WM Ord File
101.2

O. L. Olson, Project Manager
BWIP Project Office
U.S. Department of Energy
Box 550
Richland, Washington 99352

FOLLOW-UP COMMENTS ON JUNE 1984 DOE/NRC HYDROGEOLOGY WORKSHOP

FIGURE 1

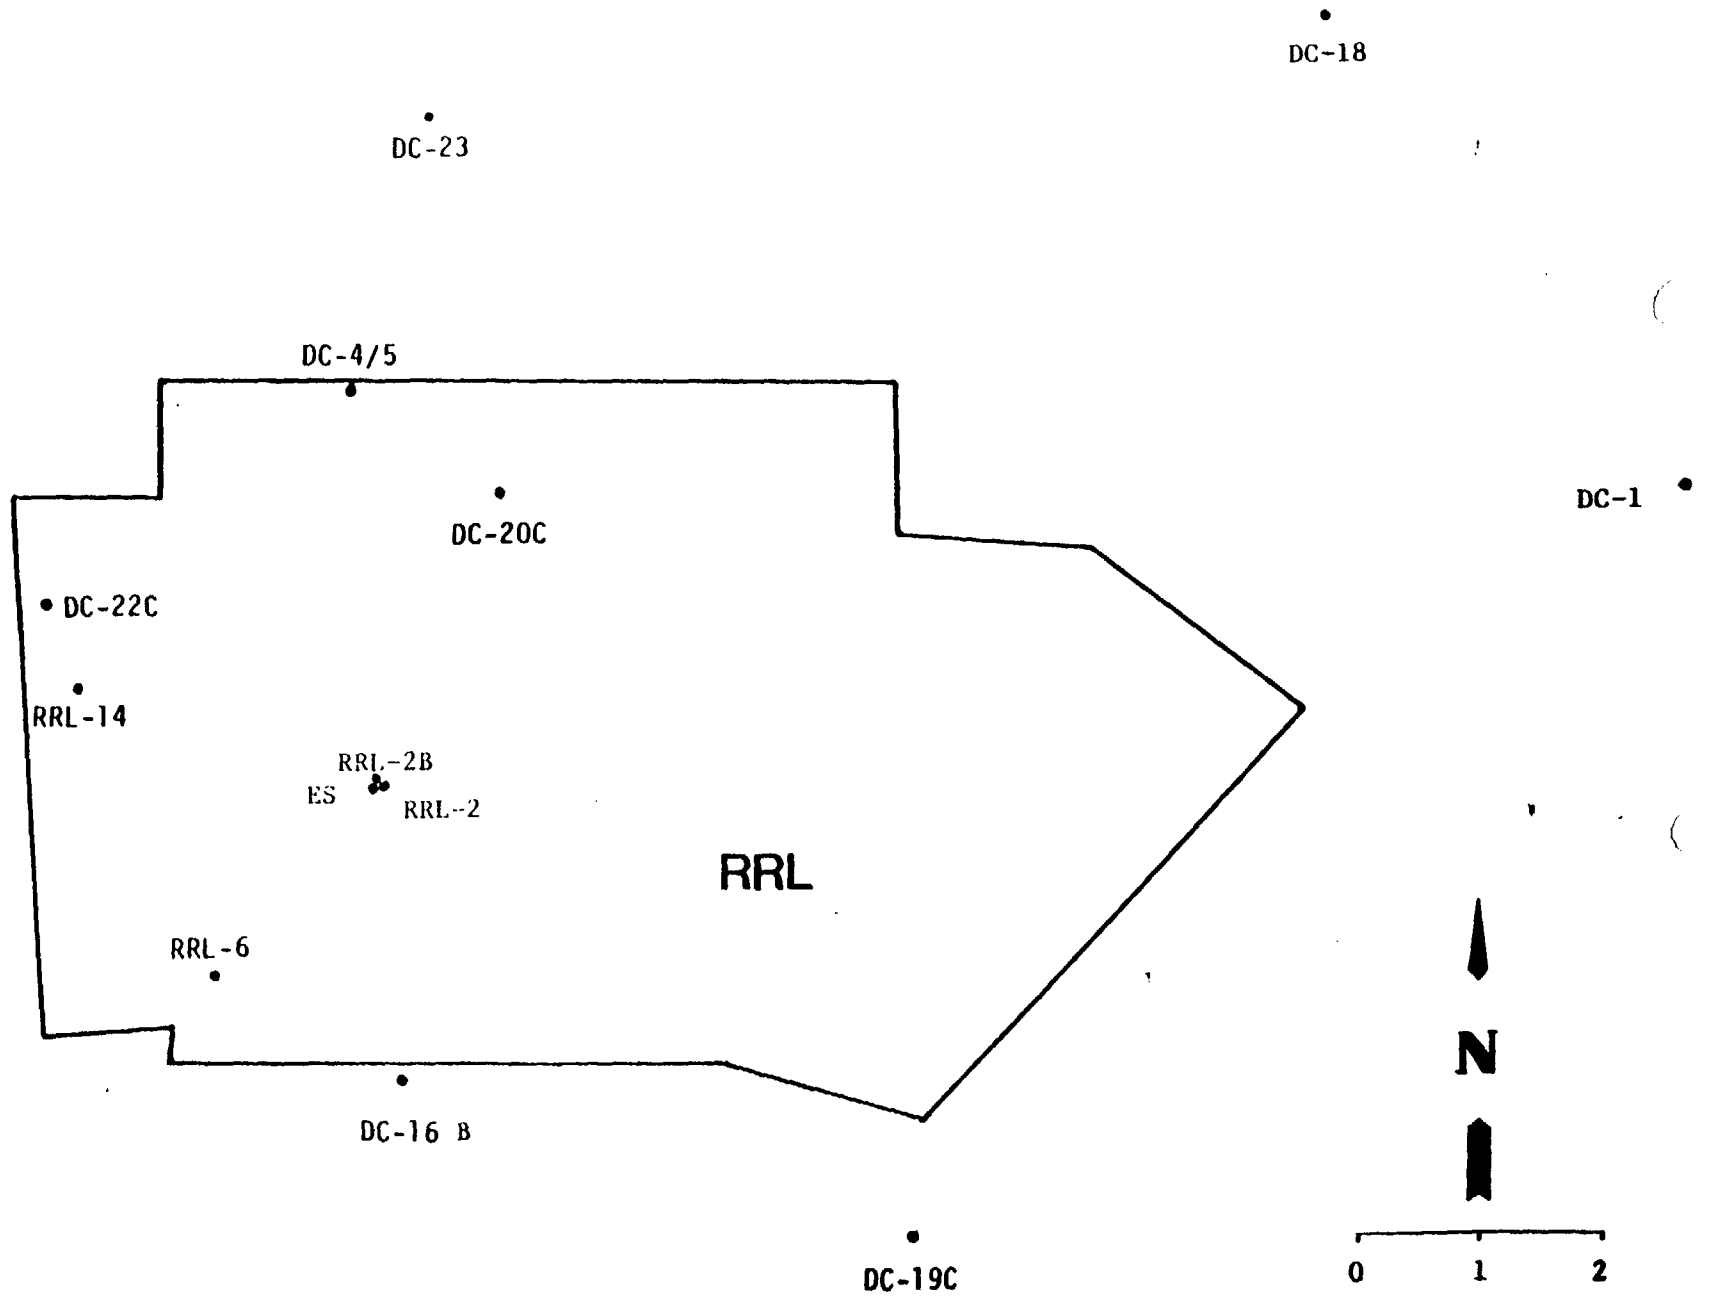
During the June 1984 NRC/BWIP Hydrogeology Workshop, BWIP presented an updated description of the status of and plans for hydrogeologic monitoring and testing at the BWIP site. The presentations indicated that substantial progress had been made toward implementation of the testing strategy discussed during the July 1983 meeting. In particular, the nested piezometers in boreholes DC-19C, DC-20C and DC-22C had been installed with reasonable success, and the hydrologic baseline monitoring had begun. In addition, the feasibility of the planned large-scale hydraulic stress (LHS) tests was clearly demonstrated by observations of drawdowns in DC-16B, DB-14, and DC-1 during air-mist drilling of the cluster "C" holes. Throughout this document please refer to Figure 1 which illustrates, relative to the boundaries of the Reference Repository Location (RRL), the locations of most of the boreholes discussed in this letter.
